Millstone Nuclear Power Station, Unit 3
NRC Chemical Engineering Branch (Fire Protection)
Review Meeting, February 16, 1984

Status of the NRC-CMEB (Fire Protection)
Draft SER Open Items Discussed at the Meeting
with the NRC-CMEB February 16, 1984

Responses to the Draft SER Open Items

SKETCH #1

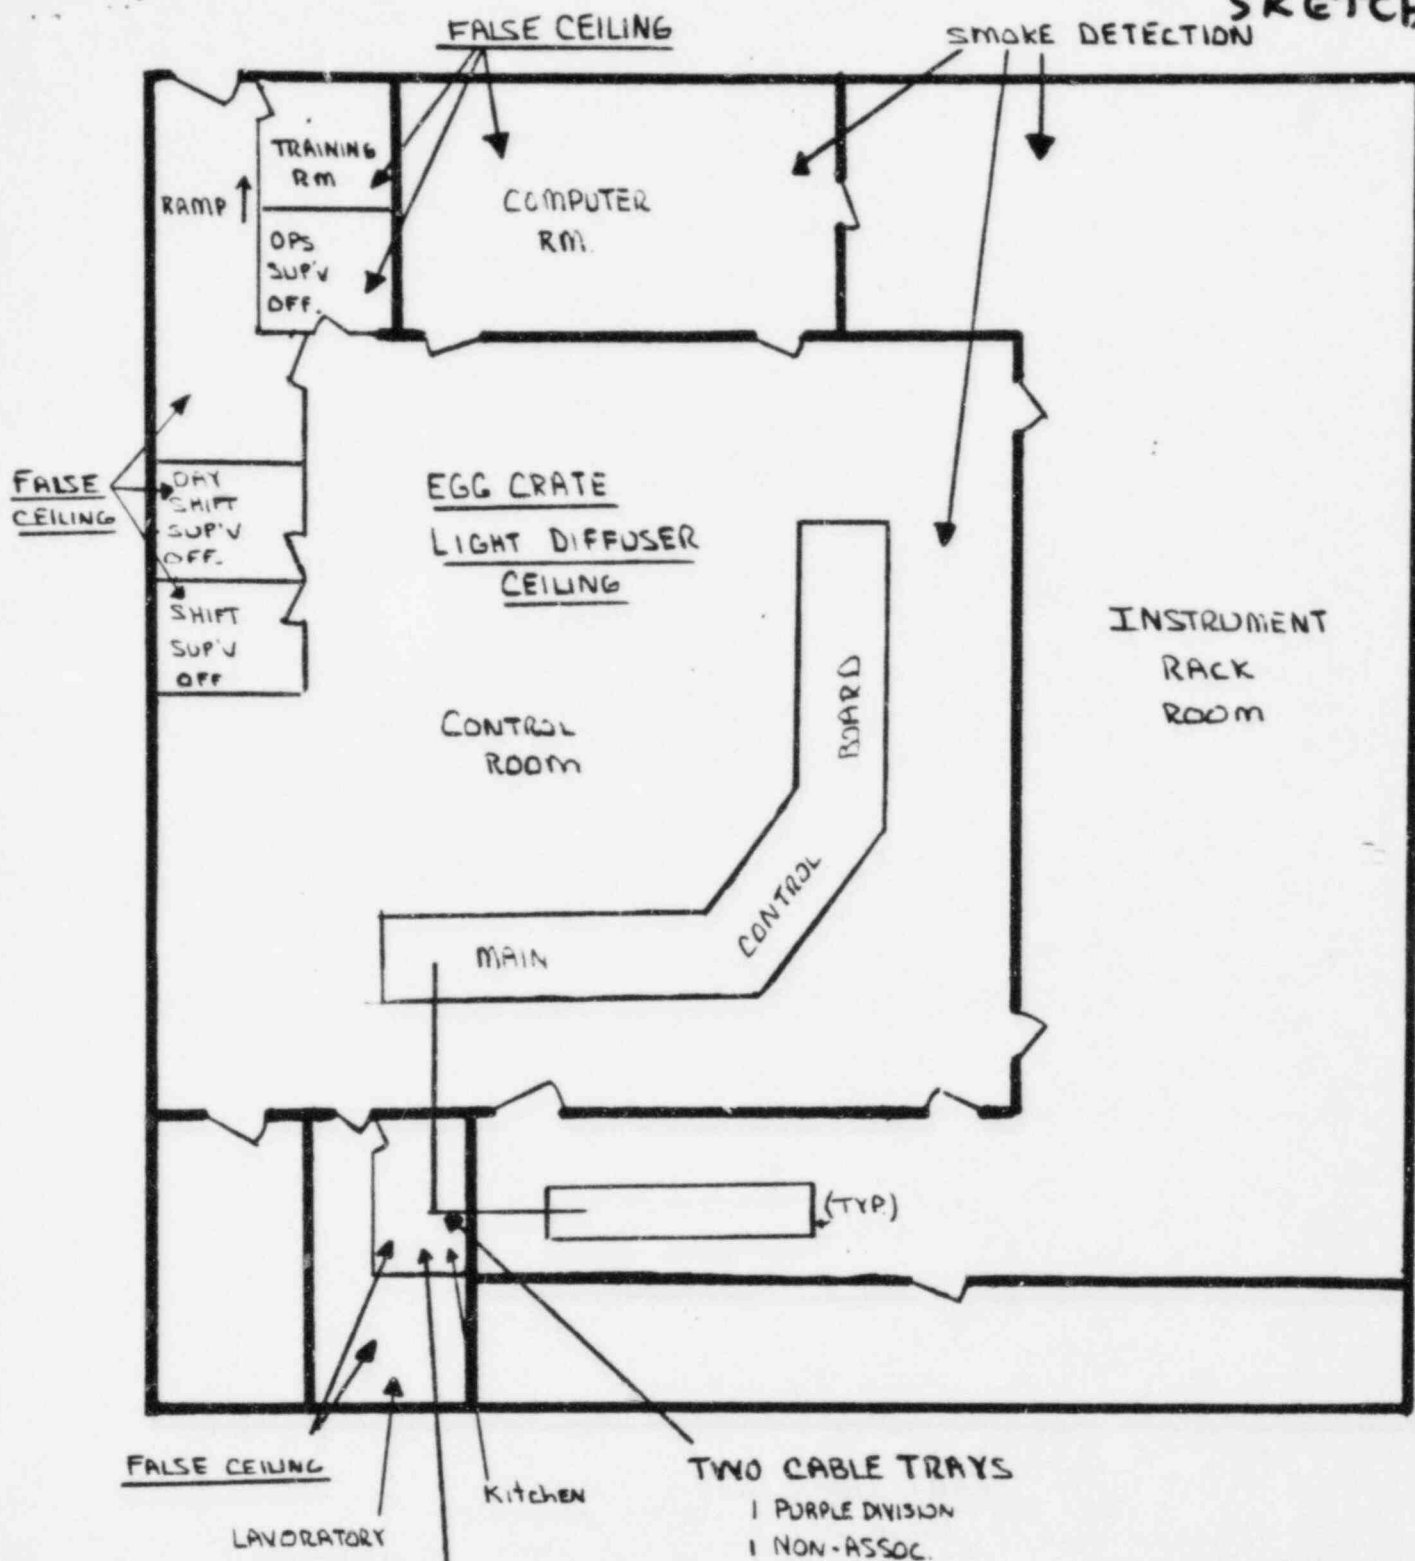
Suspended ceilings and their supports are of noncombustible materials, but concealed spaces above the suspended ceiling are not described as being devoid of combustibles. We will require the applicant to confirm that concealed spaces above suspended ceiling meet the guidelines of BTP CMEB 9.5-1, Section C.5.a(11). This is an open item.

- o Suspended ceilings do exist in the peripheral areas of the control room complex. Combustibles above these ceilings are limited to two 8" wide cable trays which carry cables from the instrument rack room to the main control board (see Sketch #1). The cables are IEEE-383 qualified and are of the purple division (1 tray) and non-associated division (1 tray). NNECO has evaluated this configuration and has committed to install a smoke detector above and below the suspended ceiling in the kitchen. The smoke detectors provide assurance that a fire will be detected in its earliest stage and that notification of control room operators (next room) will occur.

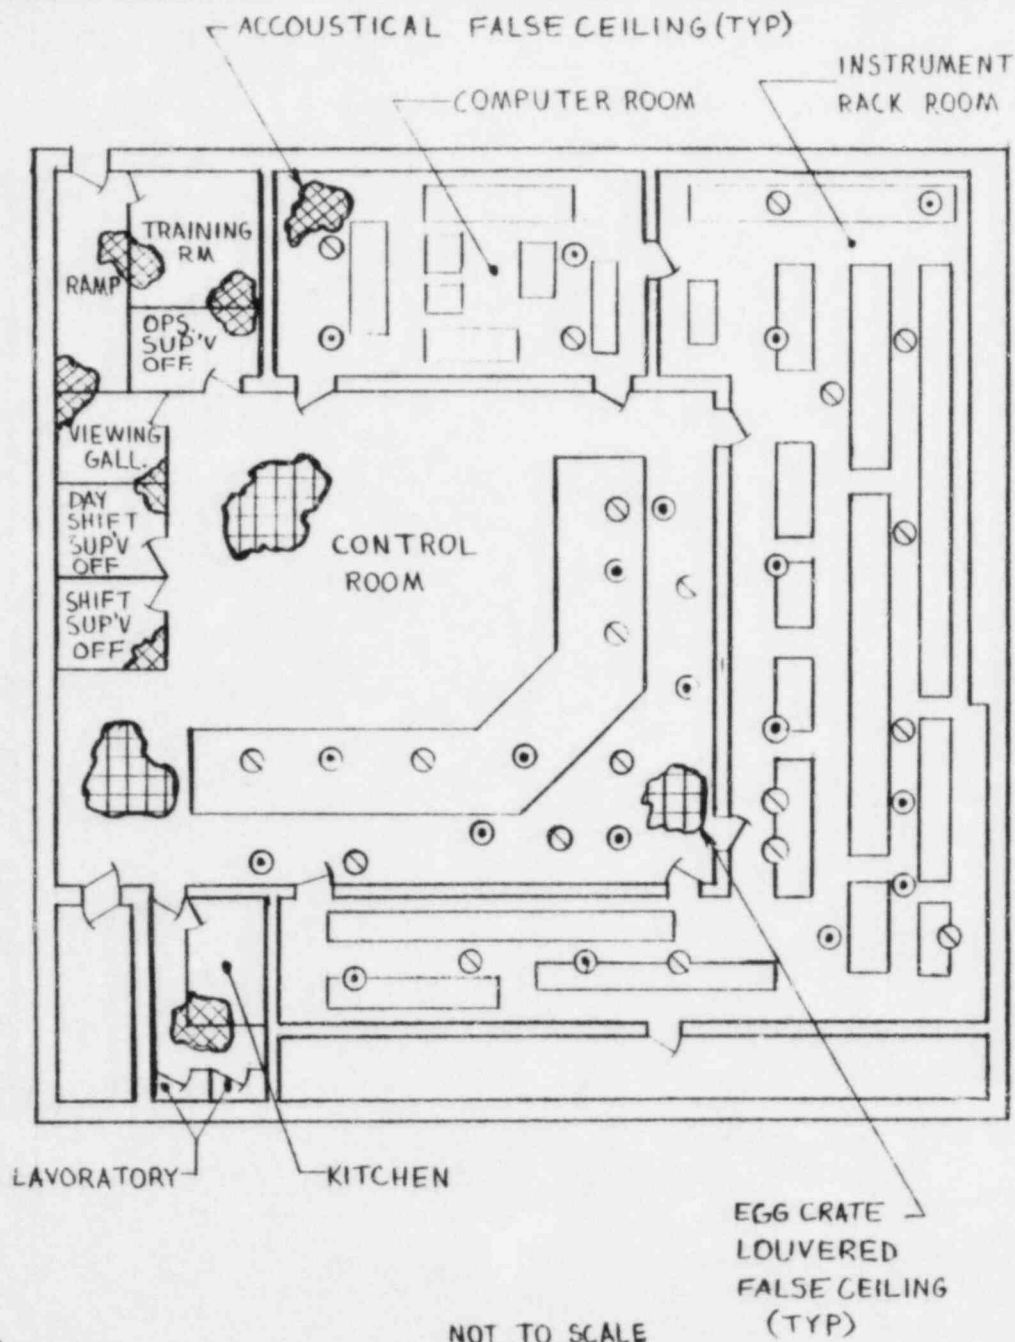
Smoke detectors are not provided inside control room cabinets and consoles. We will require the applicant to install such detectors in accordance with our guidelines in BTP CMEB 9.5-1, Section C.7.b. This is an open item.

Millstone 3's Control Room has been provided with a general area smoke detection system. This detection system utilizes a combination of photoelectric and ionization type smoke detectors in order to provide an early warning of a smoke/fire condition (refer to the attached drawing for the detector layout). Since the major fire loading within the control cabinets is cable insulation, which represents a smoldering type fire, detectors are located at the ceiling level of the room utilizing the applicable sections of NFPA 72E as guidance. In addition, cable tray arrangements and ventilation paths, both in the room and control cabinets were considered when determining the appropriate detector location. Alarm annunciation of a detector will occur at both the main control board and the fire control panel. Both locations are provided with an audible/visual alarm to alert personnel of a smoke/fire condition.

Natural ventilation paths within the control cabinets move in the upward direction toward the ceiling area. Louvers located in the bottom sections of the cabinets provide the means for air intake. Air exhaust and the removing of any heat build-up within the cabinet is achieved by openings provided for cable routing at the top of the cabinet. This upward ventilation path will not only remove any heat generated but will also carry any products of combustion upward to the room ceiling area which is provided with smoke detectors, thus resulting in the detection and early warning of a smoke/fire condition.
